**Des Bee Dove Mine, Phase 2 Reclamation Plan Appendix XV Change Order Amendment
Submittal, PacifiCorp, Des Bee Dove Mine, C015/017, Emery County, Utah**

**DES-BEE-DOVE MINE
PHASE 2 RECLAMATION
Change Order Chronology**

Change Order #2

Map 500-4: Reclamation Sections

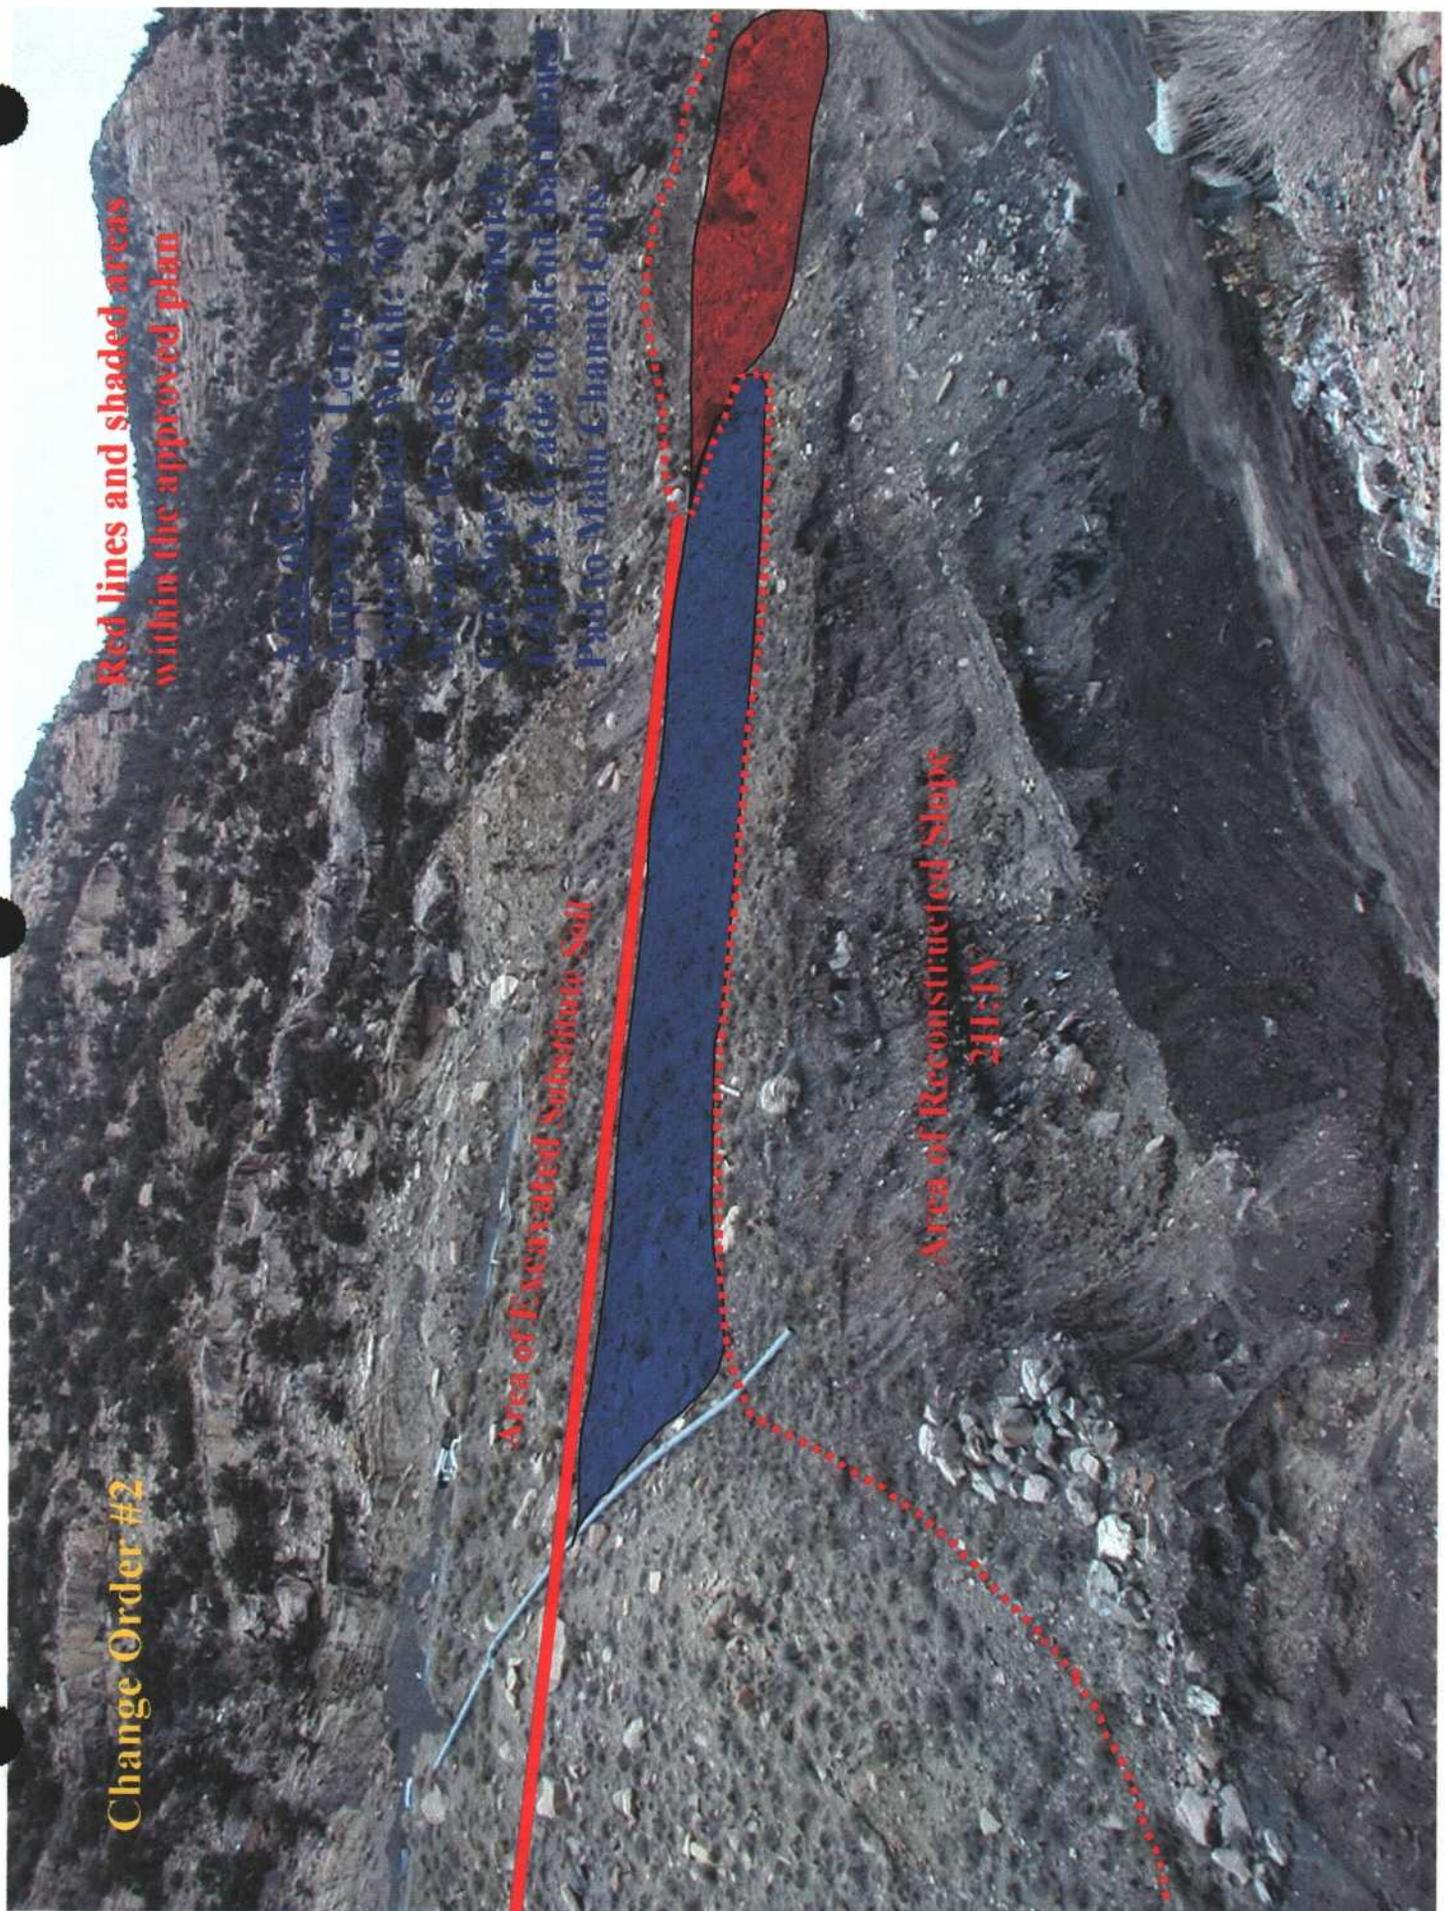
Change Order #	Date	Area	Description of Change
2.	3/27/03	Main bathhouse pad outslope from approximately 3+00 through 7+00	<p>In an effort to improve reclamation final slope configuration the contractor requested permission to re-work the bathhouse pad outslope to the main channel from cross section 3+00 through 7+00. The advantages/disadvantages to this requested change order will be:</p> <p><u>Advantages:</u></p> <ul style="list-style-type: none"> * Reduced final slope configuration from 1.3H:1V to 1.9H:1V * Increase slope stability * Increase in substitute topsoil quantities * Improved reclamation safety * Improved overall reclamation efficiency * Improved reclamation techniques <p><u>Disadvantages:</u></p> <p>Disturbance of approximately 0.6 acres</p> <p>The additional disturbed area will be approximately 0.6 acres. Additional soil material excavated will be utilized along the main drainage side slopes. Overall the slope will be graded/re-worked from existing slope of 1.3H:1V to a slope of approximately 1.9H:1V. The area will be seeded as specified in the Biology Section. Additional area for hydroseed application is approximately 0.6 acres. Slope material consist of overcast material from the original bathhouse pad construction and the original slope. Overcast and native material ranges from silt/sand to large boulders (sampled in soil trenches T7 and T8, refer to Phase 1 soil analysis). Large boulders will be segregated for use as riprap. Excess soil, approximately 10,000 yards³ (this figure excludes the soil necessary to cover the bathhouse spoil material to a depth of approximately 2.5'), from this area will be transferred to cover the main drainage side slopes. A series of three random location soil samples will be collected along the slope below 3' from the original slope and tested for a minimum of pH, SAR and EC. Review Change Order #2 Photos.</p> <p>In addition, as discussed on-site, development of the main channel has facilitated shifting the main channel from Station 10-12 approximately 40' to the east. This is considered engineering field fit. As a result, excess fill from the tipple area will be used to create fill slope on the west side of the channel at Station 11.</p>

Cut Slope to Approximately
1.9H:1V Grade to Blend Bathhouse
Pad to Main Channel Cuts, and
Reduce Overall Grade.

- * All reconstructed slopes will be developed to 2H:1V or less
- * Bathhouse Pad outslope will a cut slope as shown on sections 4+00 through 6+00 which will reduce the slope from 1.3H:1V to 1.9H:1V

Average Depth of Cut = 11'

Existing Slope: 1.3H:1V

Projected Cut Slope: 1.9H:1V

Average Depth of Cut = 14'

Existing Slope: 1.4H:1V

Projected Cut Slope: 1.9H:1V

Average Depth of Cut = 15'

Existing Slope: 1.3H:1V

Projected Cut Slope: 1.9H:1V
